CITY OF WOODBURN
COMMUNITY DEVELOPMENT

MEMORANDUM

Date: June 8, 2020
To: Dago Garcia, P.E., City Engineer
Cc: Chris Kerr, AICP, Community Development Director
Roy Hankins, PE, Emerio Design
From: Colin Cortes, AICP, CNU-A, Senior Planner *cc*
Subject: **Planning Division review comments on original / 1st submittal of civil engineering plans for Smith Creek Development Phase 3B**

SHEET
03 OF **31**

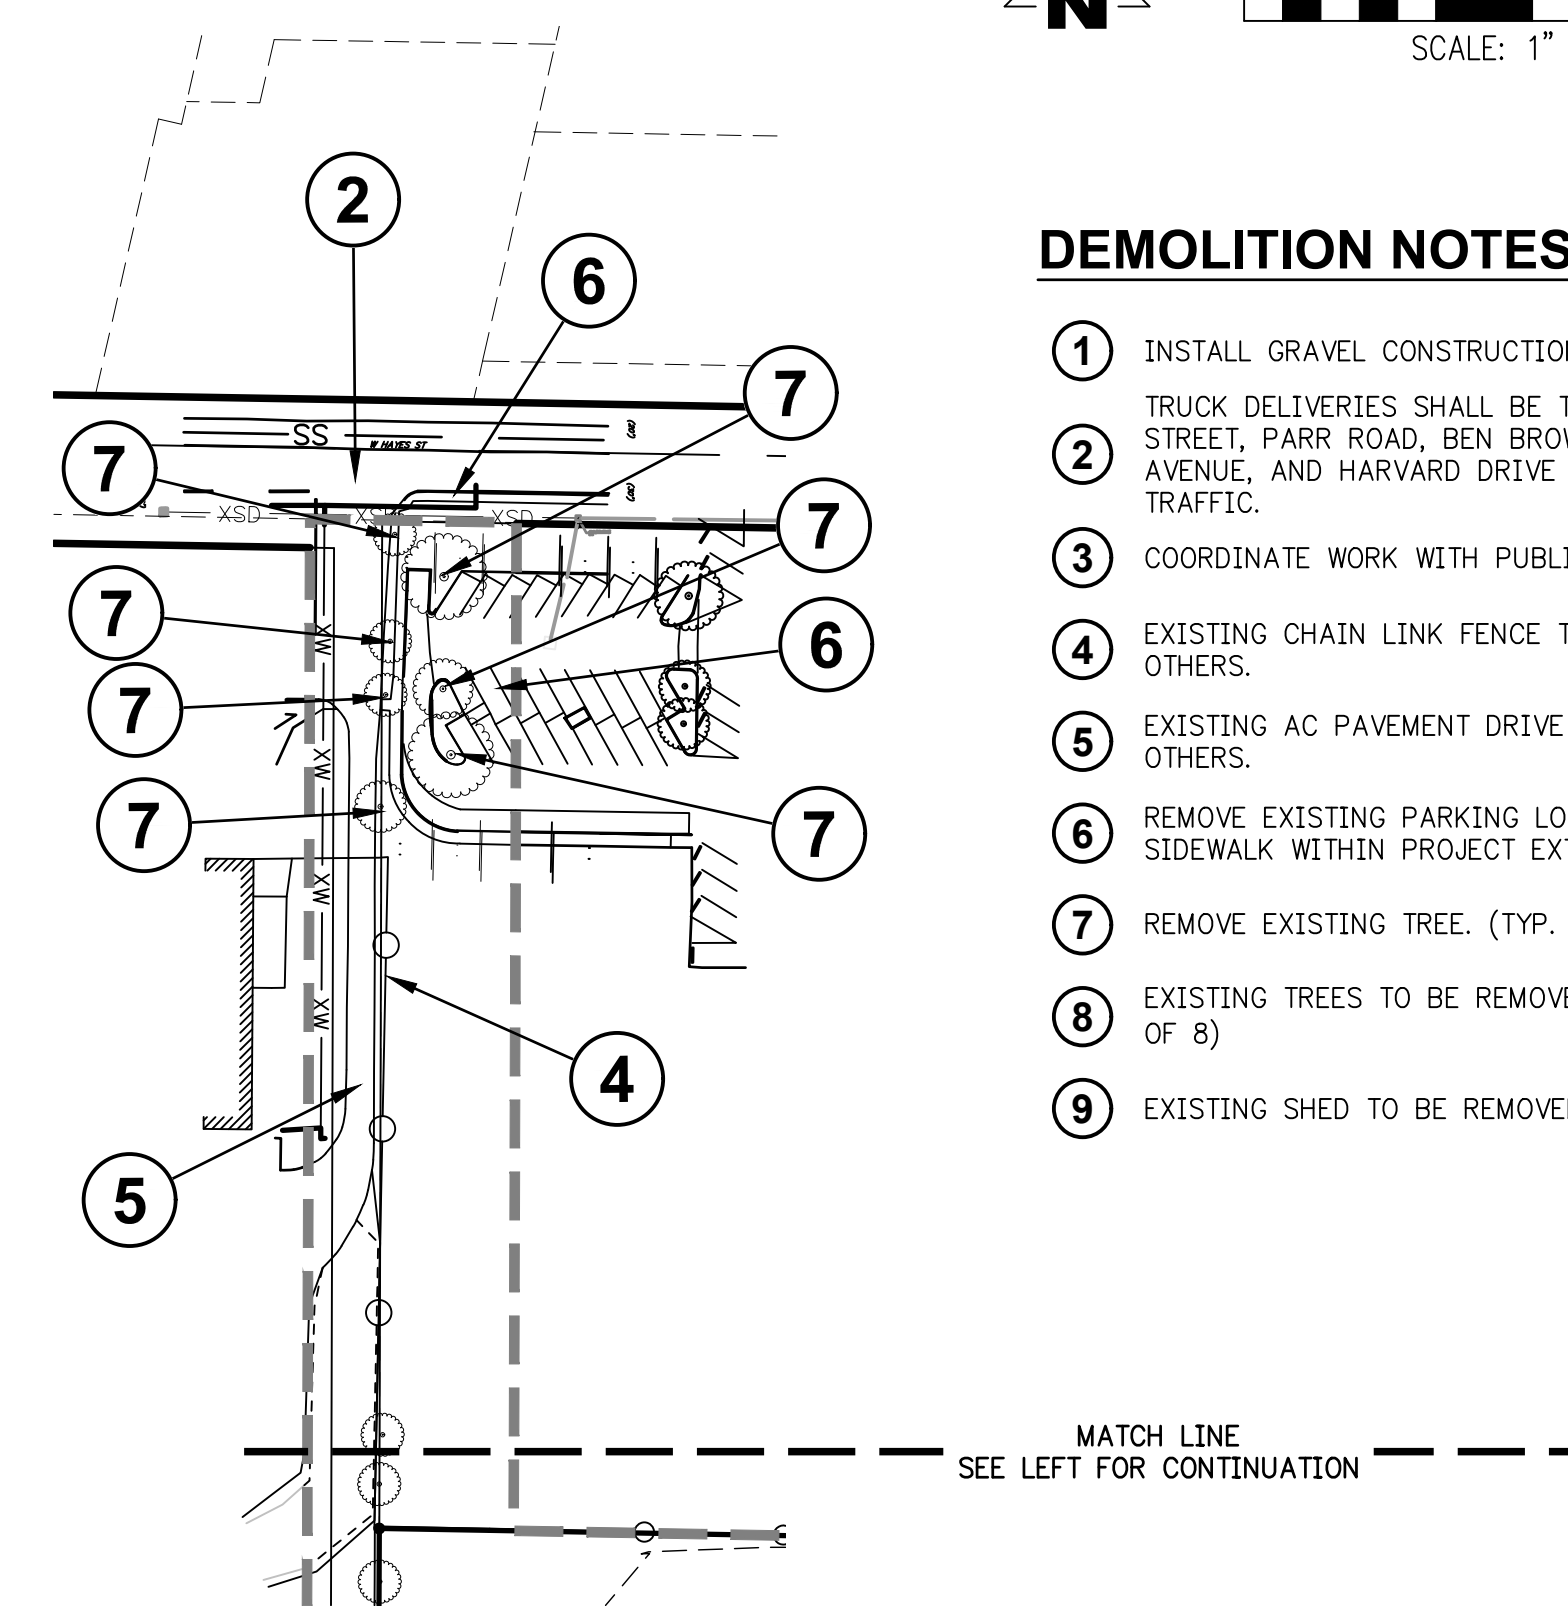
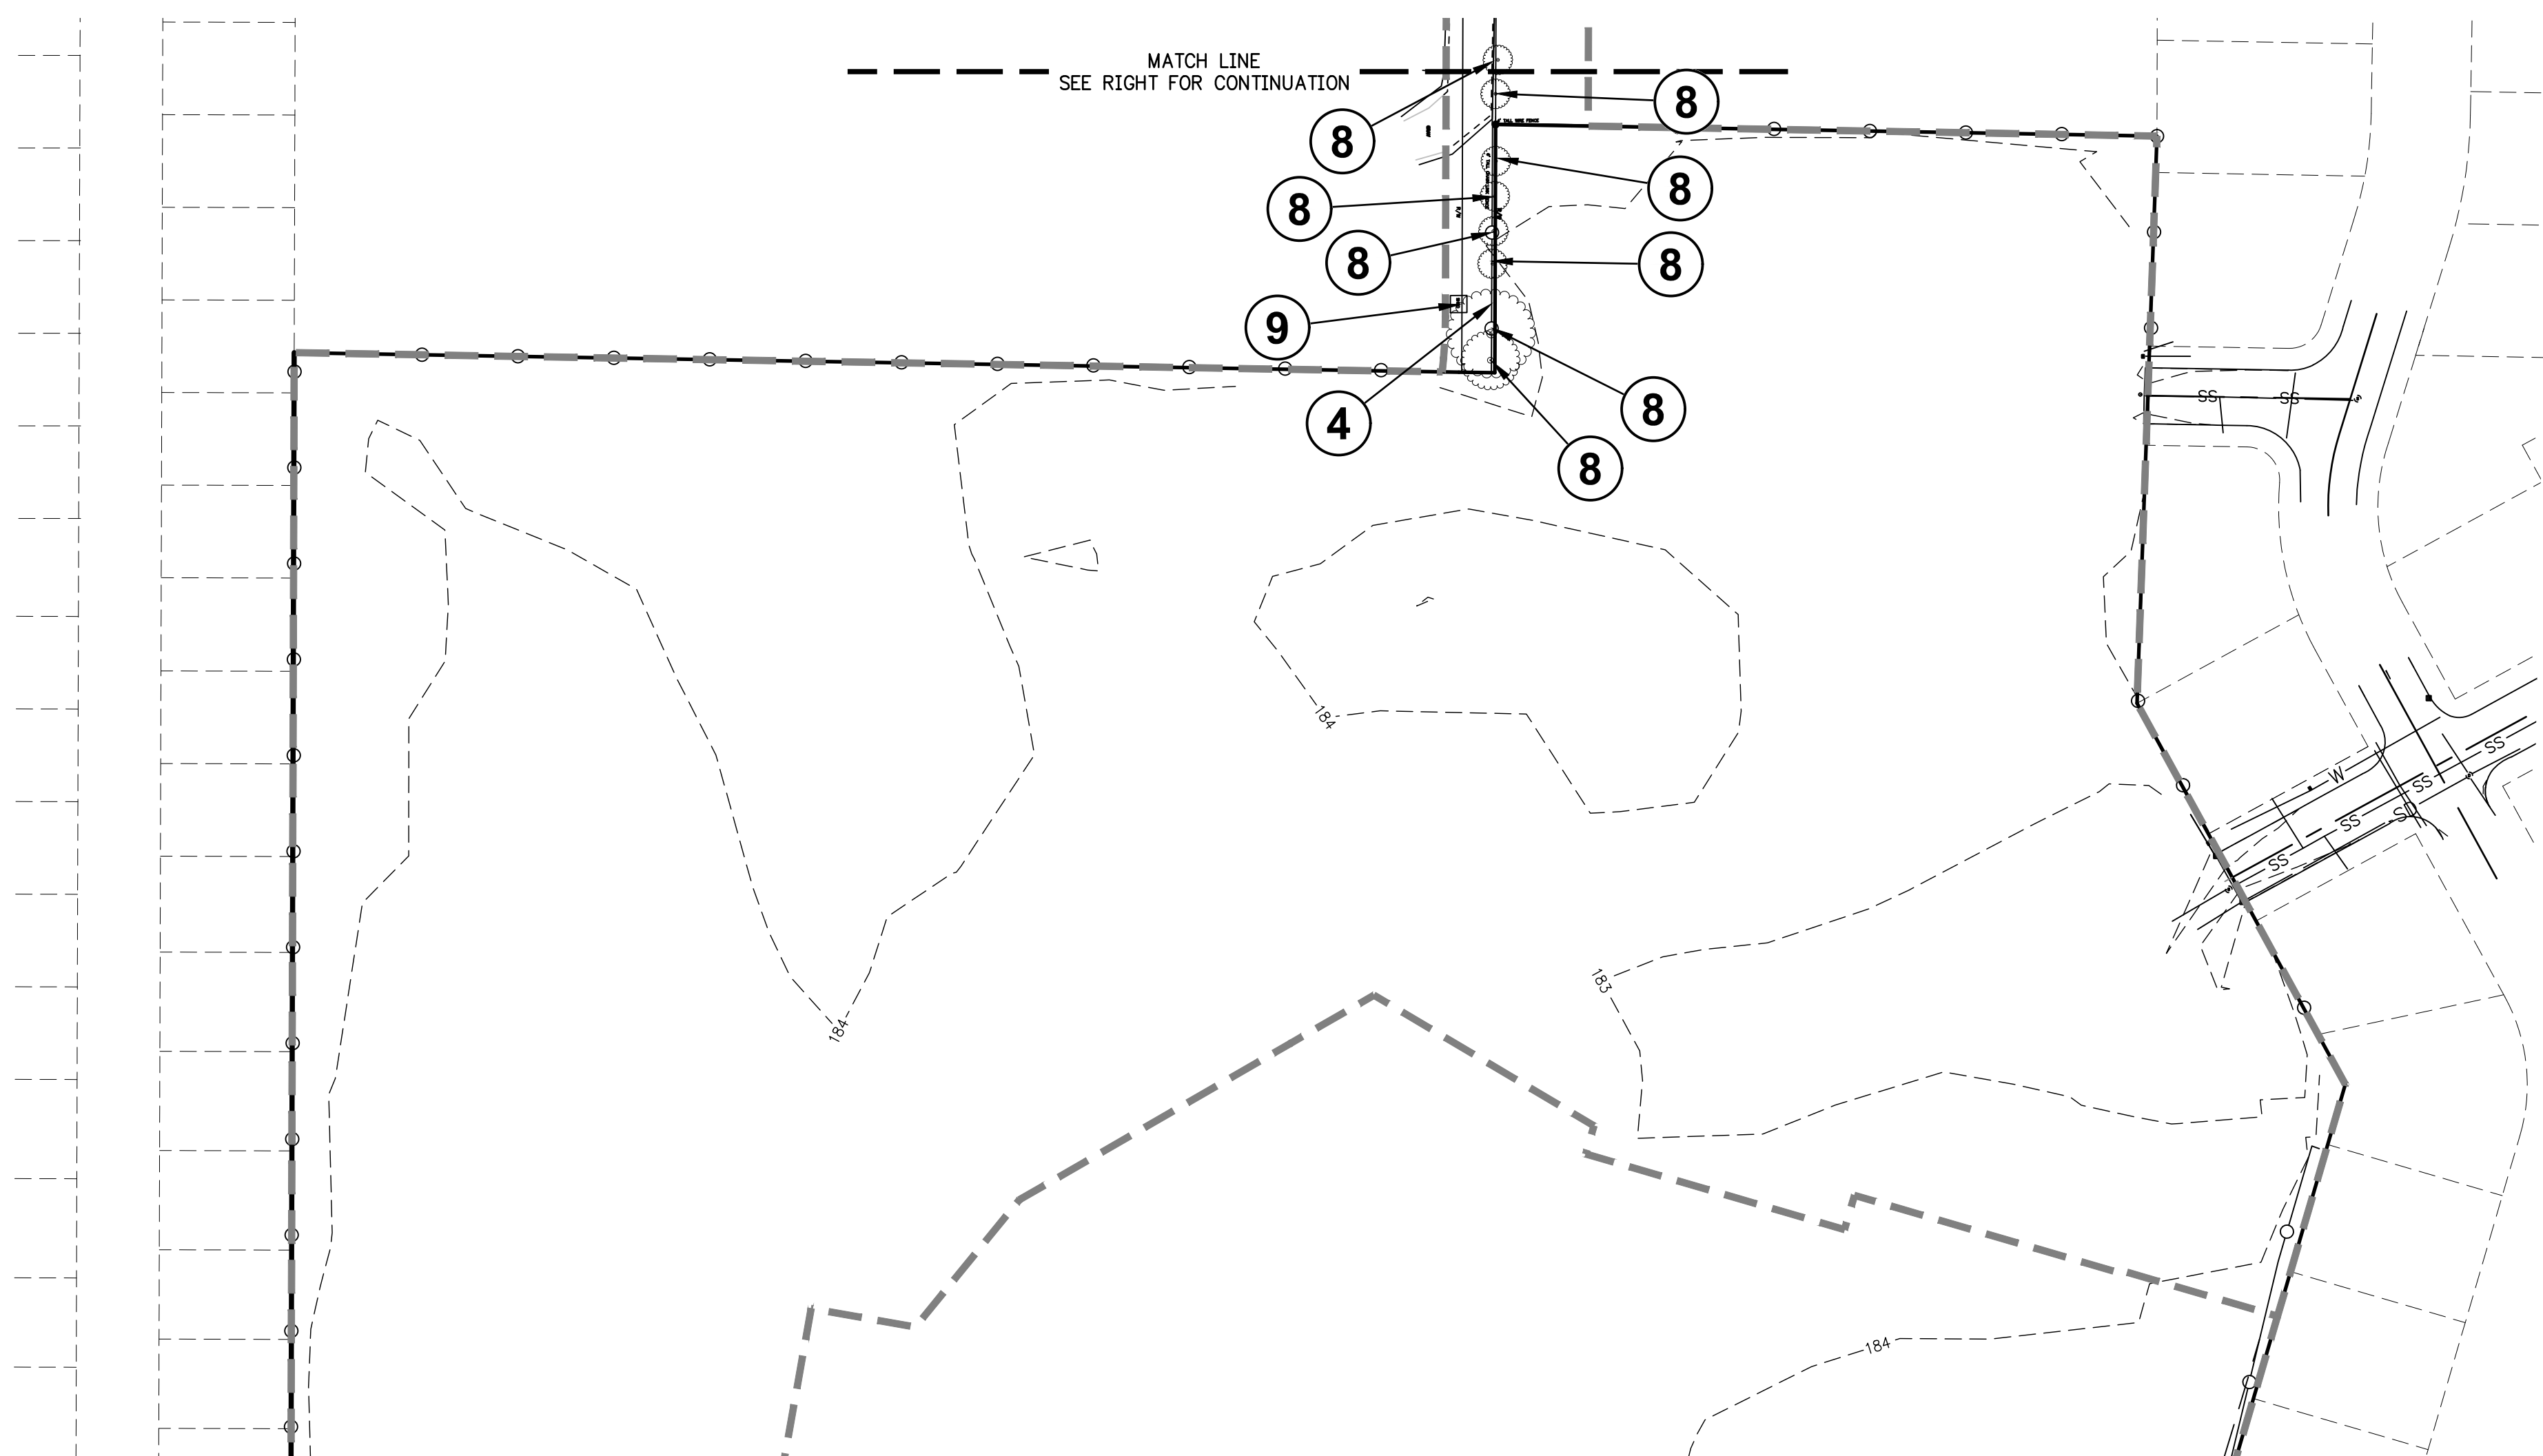
- A. Crosswalk treatments:
 - Sheet 3: Stamped concrete crosswalks typical section; and
 - Sheet 16: Curb return details 7, 9, 10, & 12:

The information is too vague to indicate pavement stamping/treatment, color, and pattern in conformance to the attached excerpted memo I'd sent Stafford Land Co. in August 2019 in response to a request to staff to direct on these topics when the issue first arose for Smith Creek through Phase 1A civil engineering plans.

Revise at least Sheet 3 to indicate conformance with the memo by providing any of notes, diagrams, and images. The excerpted memo is Attachment 1.

**EXISTING CONDITIONS AND
DEMOLITION PLAN**

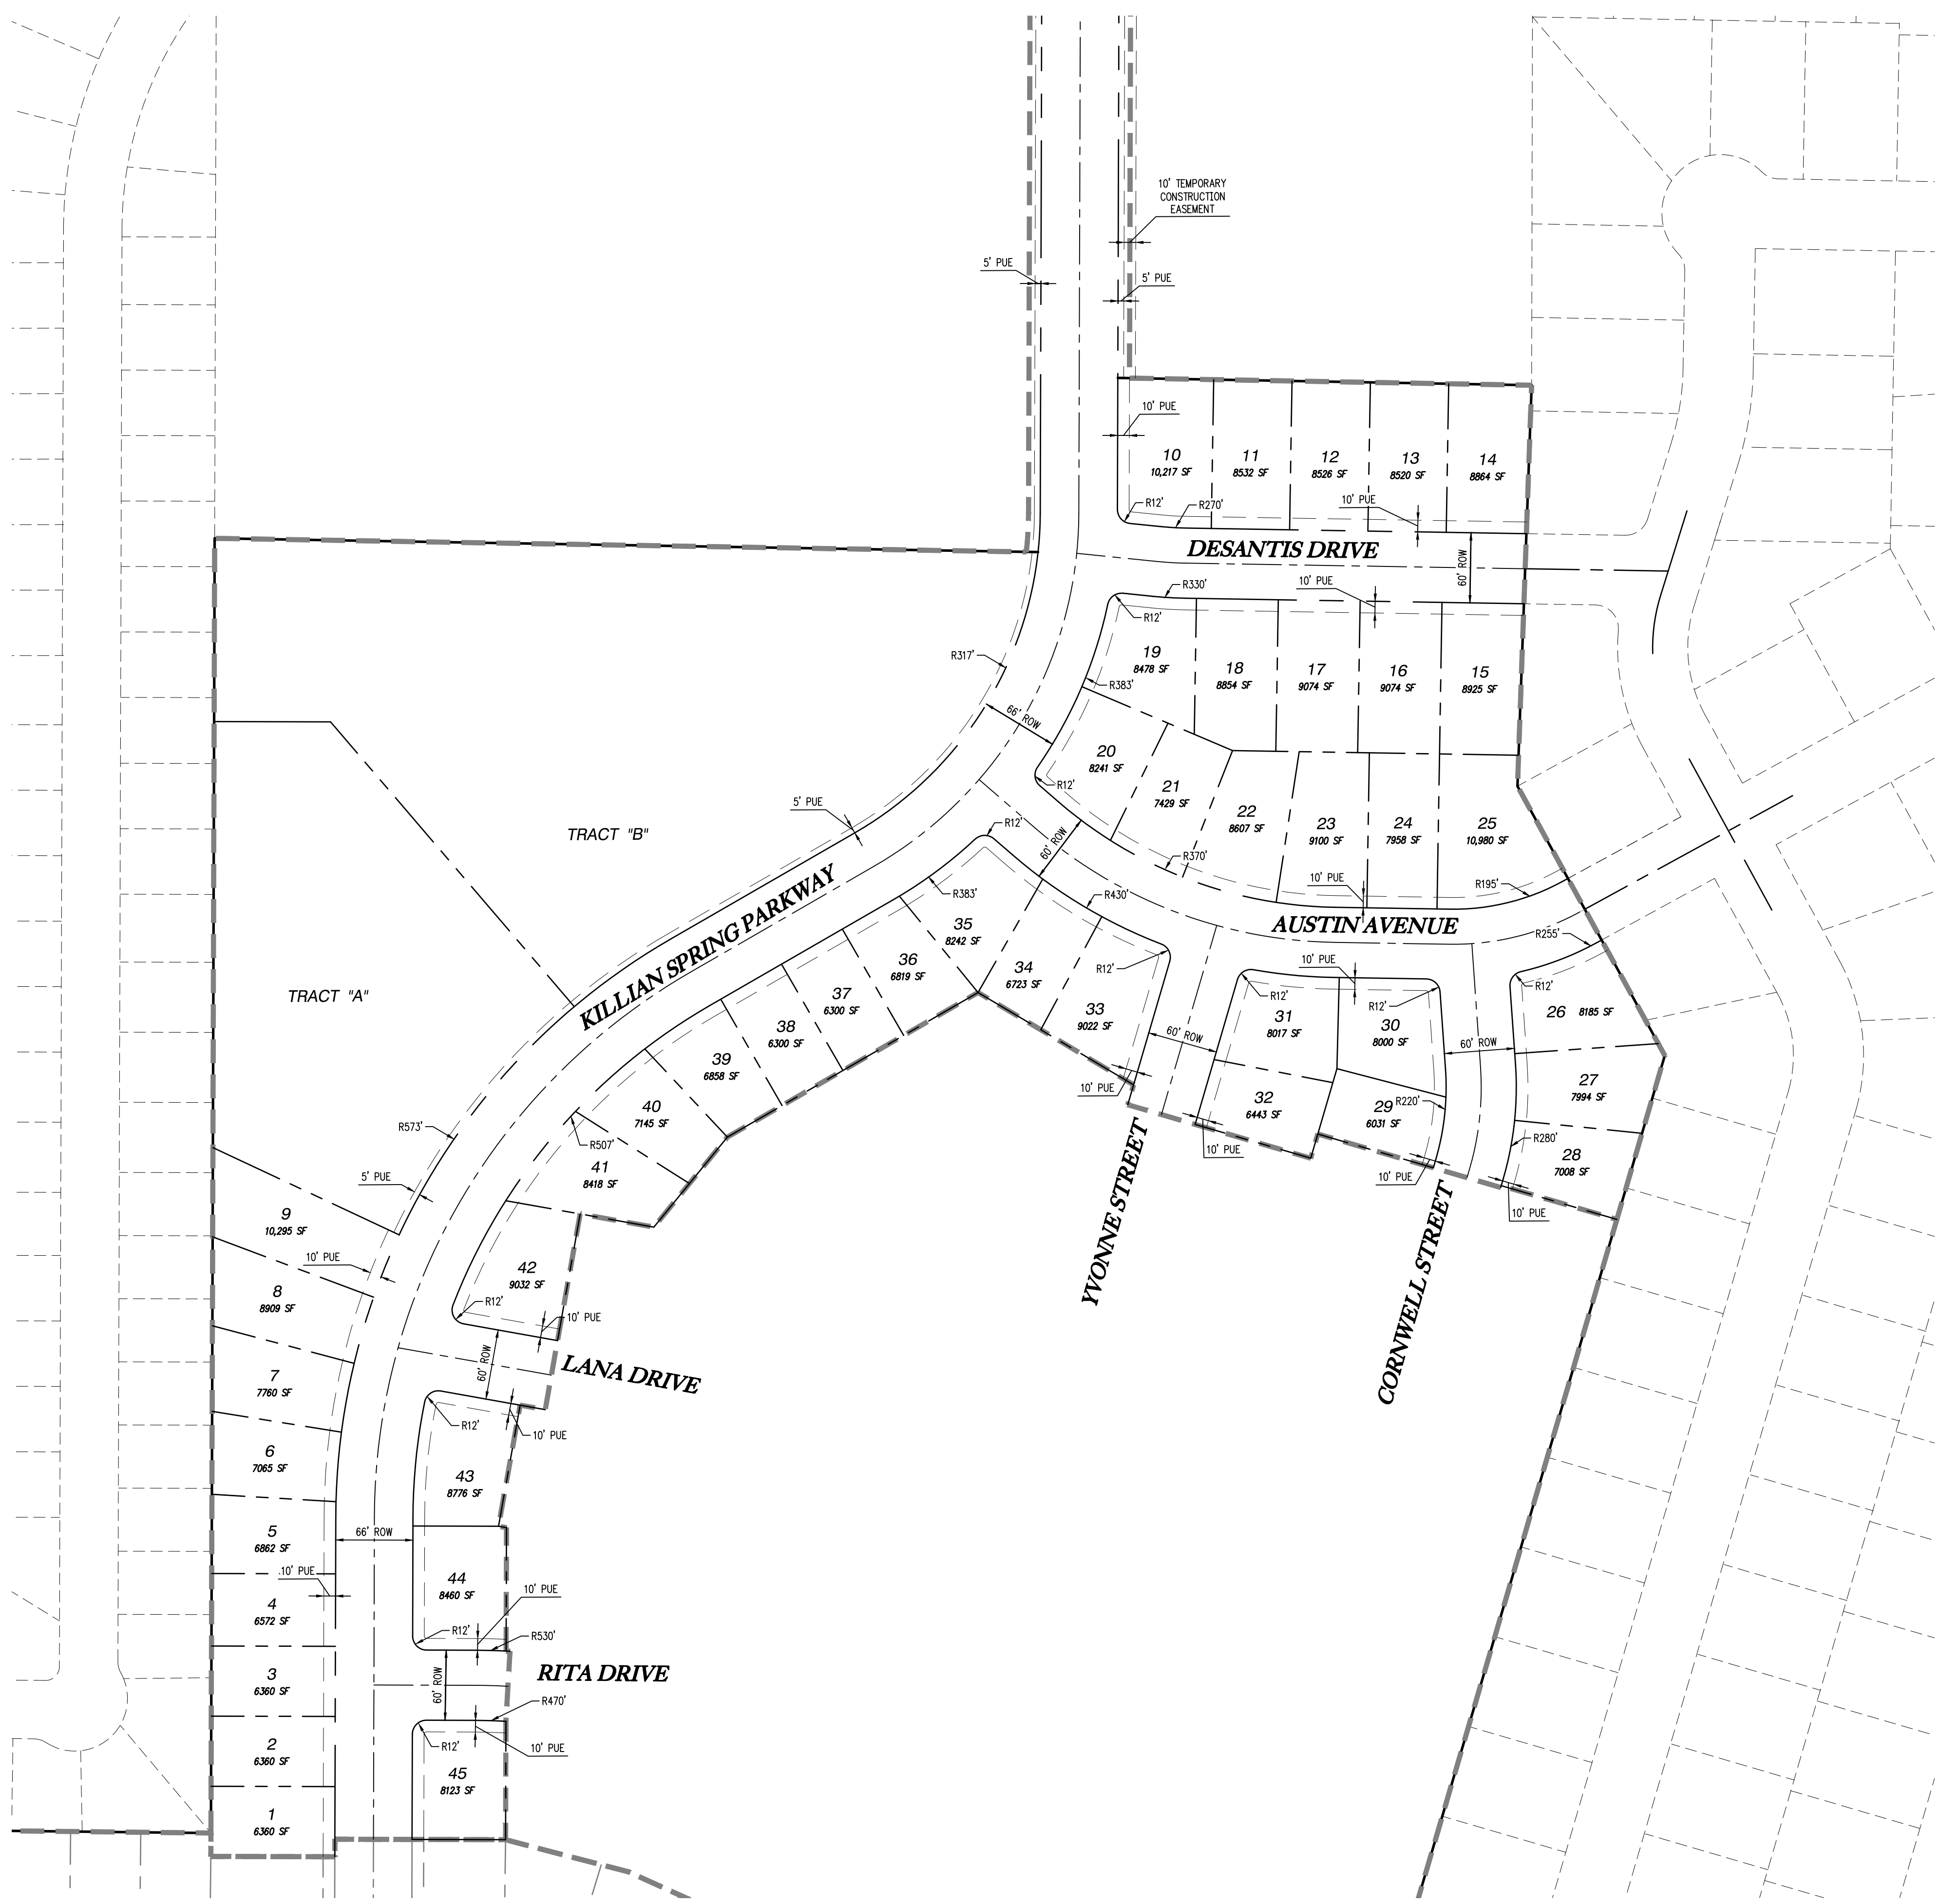
I recall that in the last two to three years Morgan Will of Stafford mentioned that St. Mary's Episcopal Church (1560 W. Hayes St; Tax Lot 051W07CC07100) had granted an easement on its property for its 46-ft wide portion of Killian Spring Drive. Additionally, Smith Creek Development [Exhibit P](#) (2018; Attachment 2) labeled "46' ROW deeded & 5' PUE granted".

However, I see no indication in City GIS or on the County tax map. (I know a tax map isn't a plat or survey, but tax maps delineate and label some easements.)

Also – and most important – the applicant having submitted Phase 3B civil engineering plans assumes that construction can meet [Smith Creek Development Final Order Condition T-A3](#) because the applicant acquired some legal right to build Killian Spring where it overlaps the church property.

I understand that the Woodburn School District dedicated ROW to the City for the school portion of Killian Spring Drive: 20 ft wide plus curvature at the intersection with W. Hayes Street per the [Exhibit P](#), as well as a public utility easement (PUE), as a result of Conditional Use [CU 2019-05](#) final decision Condition C1a.

If there isn't such easement, confirm and explain in a note on Sheet 4 and explain how the applicant would resolve the situation to meet the condition; if there is such easement or other legal mechanism allowing for Killian Spring to overlap the church property, revise Sheet 4 with a note or notes – including reference to the Marion County reel/volume and page numbers – to indicate and revise the drawing to delineate the extent of territory that the easement or legal mechanism covers. Also provide a copy of the recorded document.

Revise the bold dark gray dashed line, which suggests a tentative state, for the west side of tentative Killian Spring to indicate that ROW and PUE already exist.
